VICTORIAN CIVIL AND ADMINISTRATIVE TRIBUNAL

VCAT REFERENCE NO. P11567/2021
PERMIT APPLICATION NO. WH/2020/1225

APPLICANT	Rodney Hamilton Tate & Alison Sarah Tate
RESPONSIBLE AUTHORITY	Whitehorse City Council
RESPONDENT	David and Gail Morrison, Blackburn Village Residents Group Inc. Blackburn and District Tree Preservation Society Inc.
SUBJECT LAND	24 Glen Ebor Avenue, BLACKBURN
WHERE HELD	Melbourne
HEARING TYPE	Hearing
DATE OF HEARING	13 May 2022
DATE OF INTERIM ORDER	13 May 2022
DATE OF ORDER	10 June 2022
CITATION	Tate v Whitehorse CC [2022] VCAT 641

Description of proposal	Construction of one double storey dwelling, front fence, outbuilding and associated works, tree removal and buildings and works within four (4) metres of trees protected under the Significant Landscape Overlay Schedule 2.
Nature of proceeding	Application under section 77 of the <i>Planning and Environment Act 1987</i> – to review the refusal to grant a permit.
Planning scheme	Whitehorse Planning Scheme
Zone and overlays	Neighbourhood Residential Zone Schedule 1 (NRZ1) Significant Landscape Overlay Schedule 2 (SLO2)
Permit requirements	Clause 42.03-2 – to construct a building or construct or carry out works a

Figure 2: Ground floor layout plan.

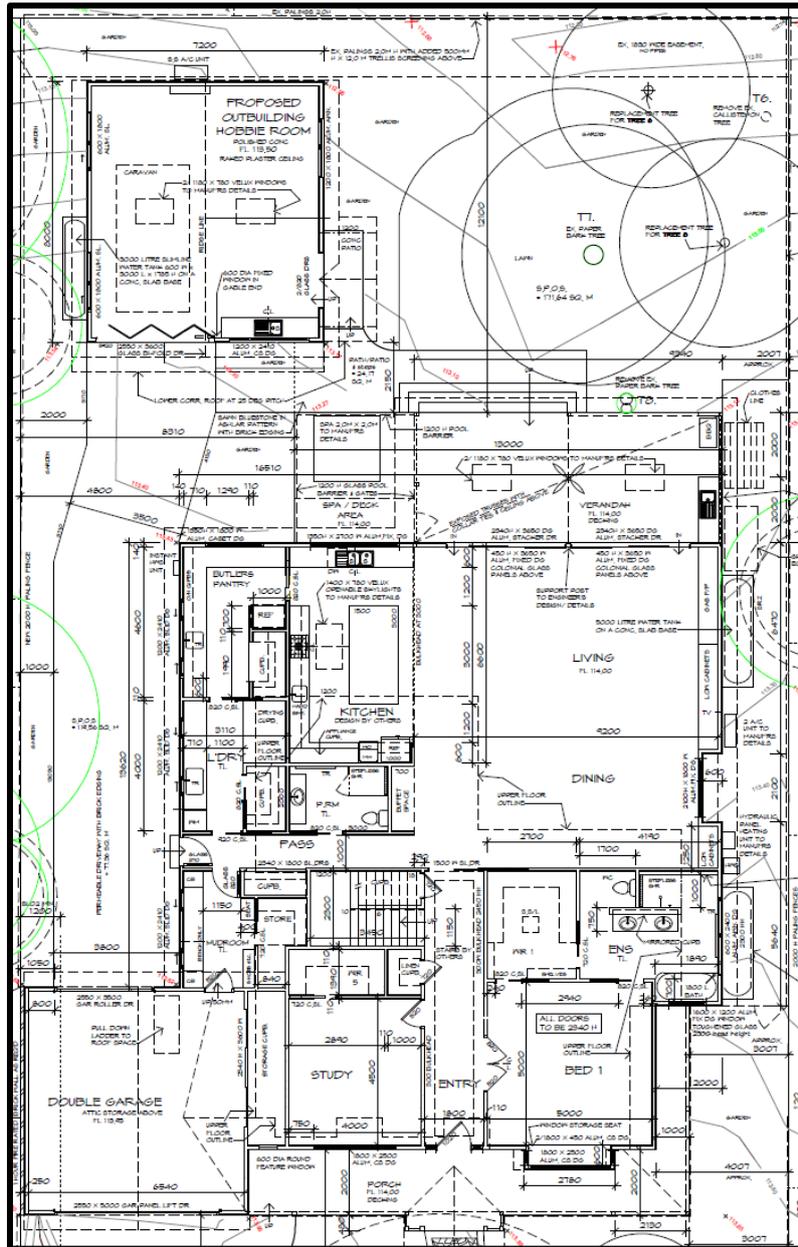
- 26 The dwelling is constructed to the eastern boundary by virtue of the garage location. Even though the garage is exempt from setback requirements, it still forms part of the overall ground level footprint and, in my view, is the most prominent element of the built form at ground level. It is set forward more than any other part of the proposed dwelling, constructed to the boundary and also includes a relatively steep roof pitch, matching that of the dwelling. It also has a relatively generous internal width of 6.54 metres.

- 27 At the hearing, I asked the applicant whether any alterations could be made to the garage to provide a setback on its eastern side. The applicant agreed the internal storage area on the western wall of the garage could be deleted. Whilst I accept that there is often a desire and need for generous amounts of storage in new dwellings, it could not be said that this proposal is short on storage. There are generous areas for storage inside the dwelling as well as a detached outbuilding at the rear measuring 8 x 7.2 metres. Accordingly, I will require that the garage be set back an additional 1 metre from the eastern boundary and have included a condition accordingly.

- (a) The garage set back a minimum of 1 metre from the eastern boundary, with no reduction of any other setbacks. Consequential internal rearrangement may be undertaken.
